**ADMINISTRATIVE PROTEST OF THE DECISION RECORD #3 FOR THE POOR WINDY FOREST  
MANAGEMENT PROJECT AND FINDING OF NO SIGNIFICANT IMPACT**

DOI-BLM-ORWA-M070-2018-0010-EA

Pursuant to 43 CFR 5003, The Klamath Siskiyou Wildlands Center (KS Wild), Cascadia Wildlands, and Oregon Wild hereby formally protest the Decision Record #3 authorizing the Blown Fortune timber sale and Finding of No Significant Impact (DR3/FONSI) for the Poor Windy Forest Management Project.

Photo 13A

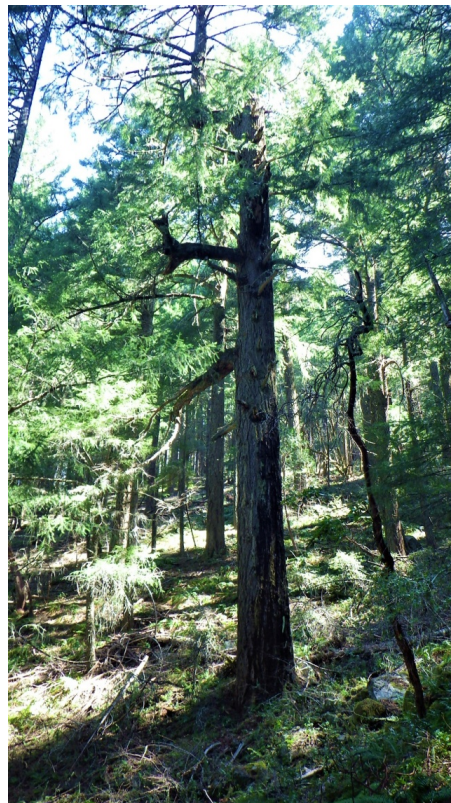
disclosing the units that have RA32 habitat. KS Wild staff have observed old growth stands within unit 23-09 that have RA 32 features: snags, nest platforms in deformed trees, large down wood and old growth trees(see photos 13a,b,c,d) . The REA fails address RA32 presence in the planning area from NSO habitat surveys. The REA fails to discuss the project scale adverse impacts from logging RA32 in HLB lands. The REA fails to analyze or disclose to the public where NR stands were not deferred.
